STATE OF MAINE
DEPARTMENT OF TRANSPORTATION
☐ Approved
☐ Returned for Corrections
AUG 2[illegible] 1997
☒ Approved as noted
☐ Rejected

PROJ. NO. : BH-043-1(34)
ITEM NO. : 520.22

PROJECT: JOSHUA CHAMBERLAIN BRIDGE OVER THE PENOBSCOT RIVER, BANGOR-BREWER, ME

EXPANSION JOINT DETAIL @ PIER 1

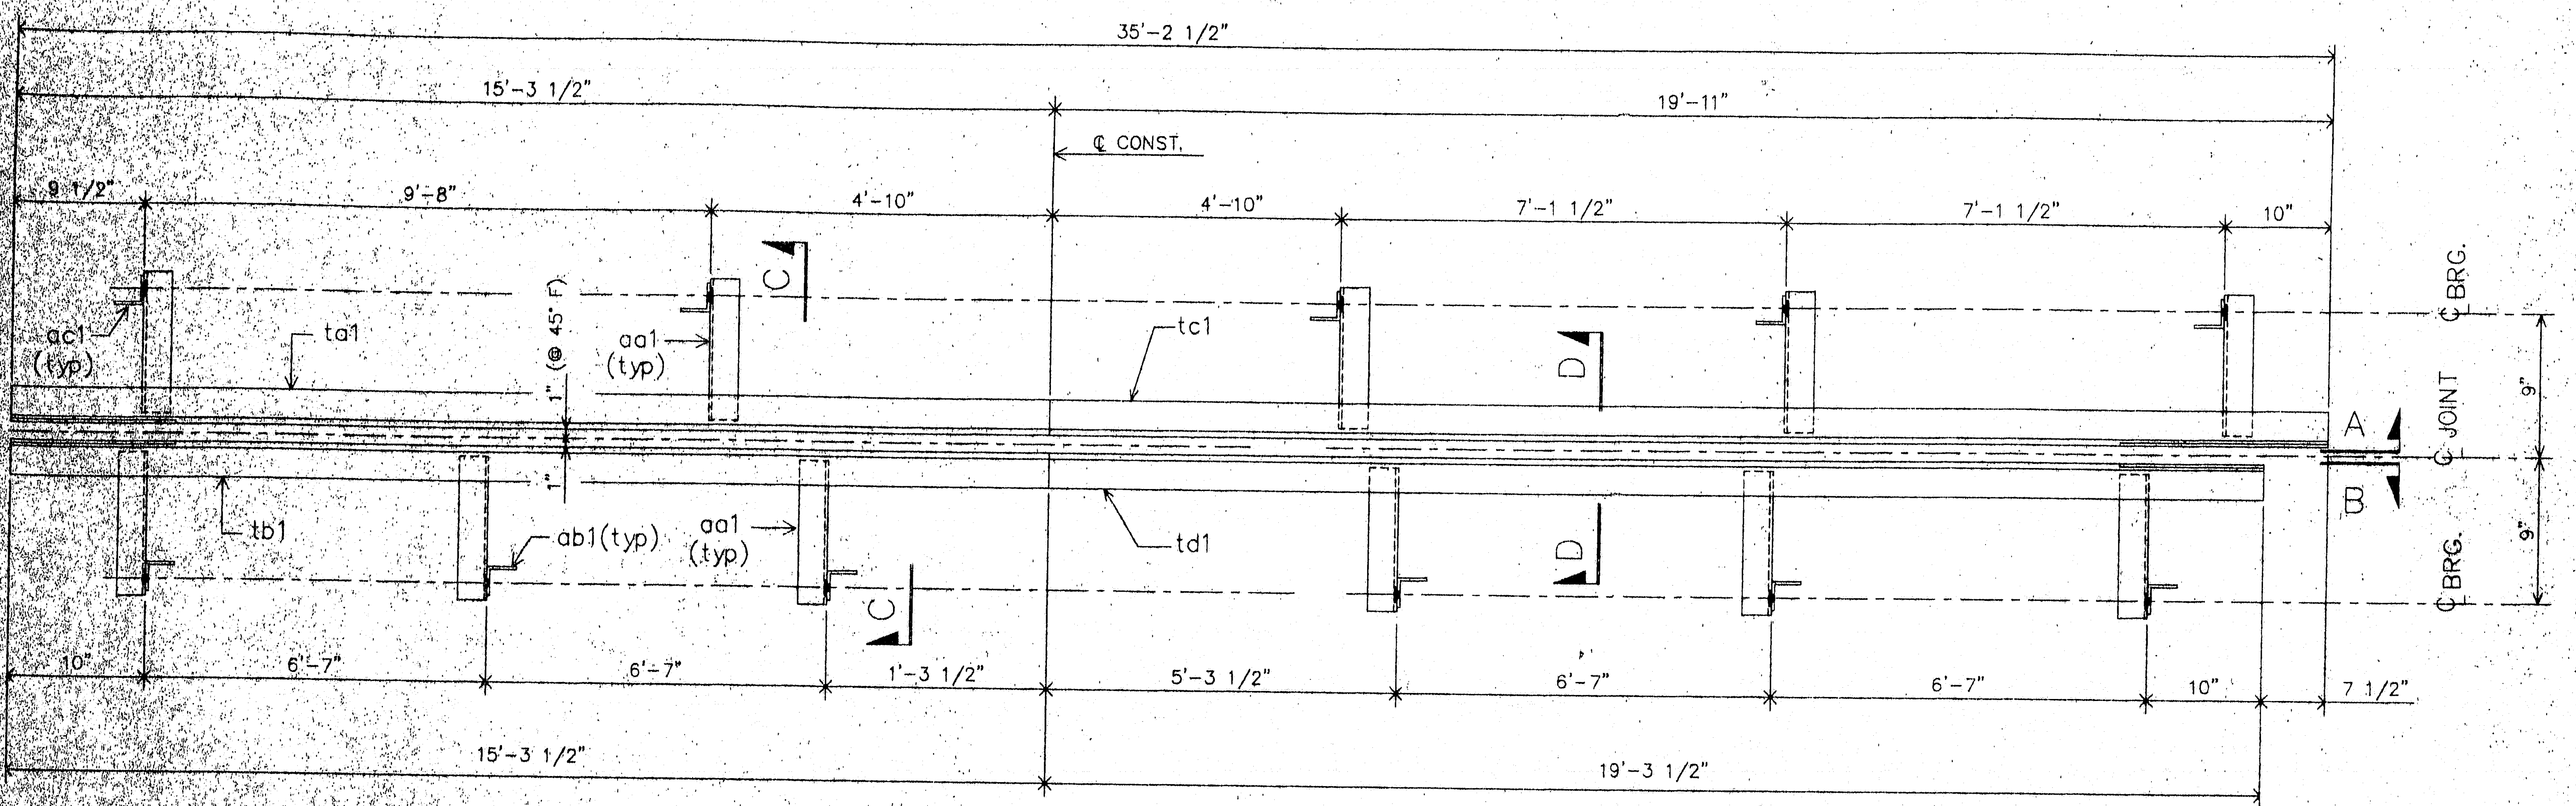
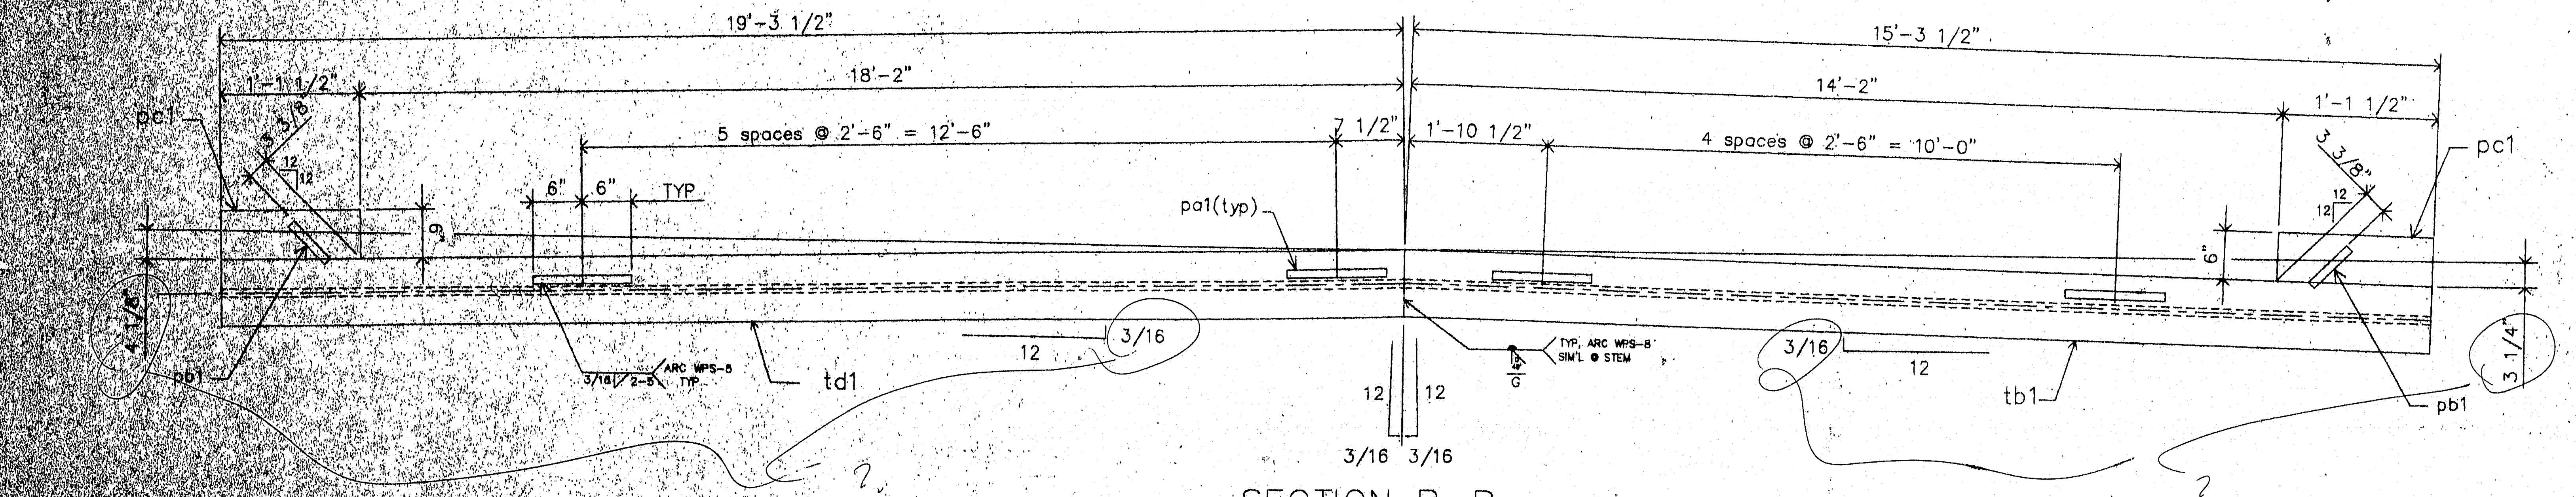
MATL: A36, UN HOLES: AS NOTED
WELD: PER PROCEDURES NOTED
PREP: SP6
PAINT: ~~3 COATS~~ - ZINC RICH PRIMER
3 MDFT PER COAT

Two Coats OK

SECTION A-A

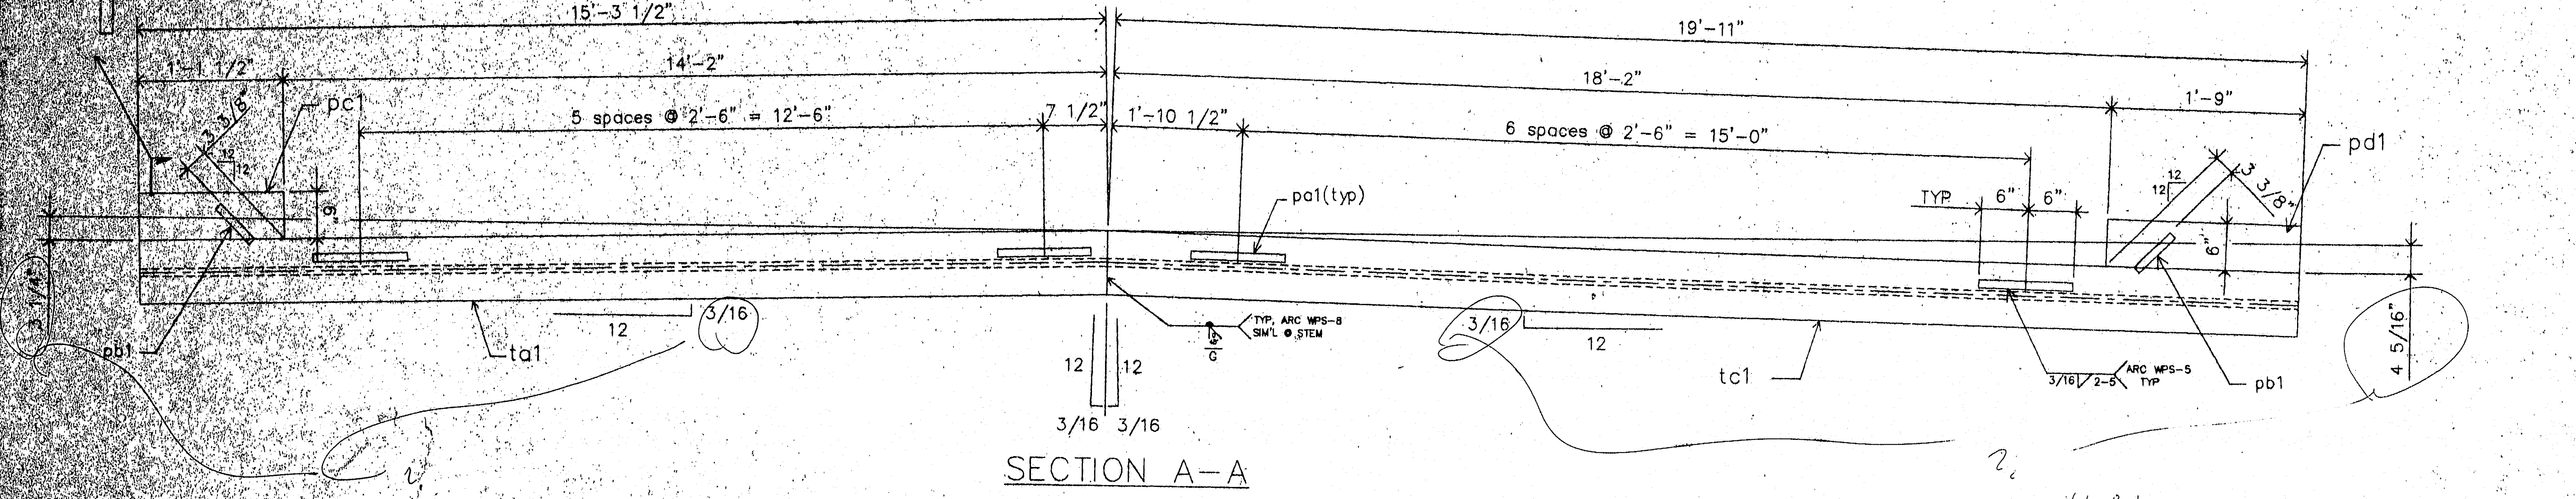
?
See sht 8 of 49 Contract Dwg.
